## **Proposal for Supplement 7 to the 06 series of amendments to Regulation No. 16 (Safety-belts)**

### **Submitted by the expert from the European Association of Automotive Suppliers \***

Figure 2

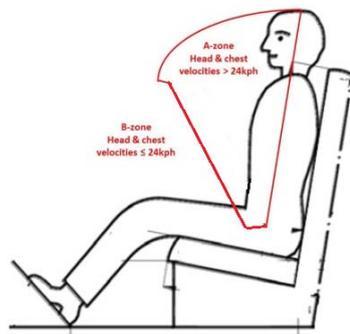
**"12.1. In case a restraint system has been granted/refused/extended/withdrawn<sup>2</sup>, those can be used for all vehicles compatible with the following dimensional conditions: no interior part in a quoted A-zone as shown below (figure 2):**

Figure 1  
Rear seats restraint system setup for dynamic test

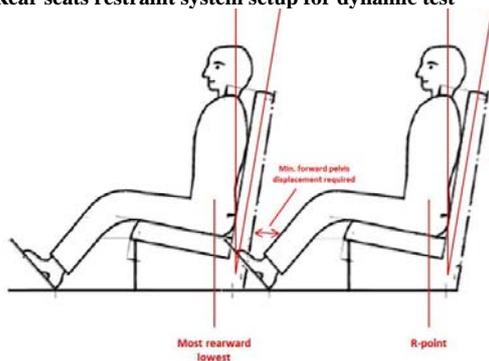
-----  
 The seat in front of a tested seat shall be adjusted to the most rearward and lowest position appropriate for any contact with the manikin installed on the rear seat, then shifted forward to ensure the minimal pelvis displacement of 80 mm or respective of 40 mm according to paragraph 6.4.1.3.2. and with a seat back angle, **if adjustable, positioned as close as possible to 10°, by using 3-D H point machine and its torso angle, (Annex 19, Figure 1).**

**This may be proved, with a contour on CAD or drawing, using the manikin described in Annex 7 to this Regulation."**
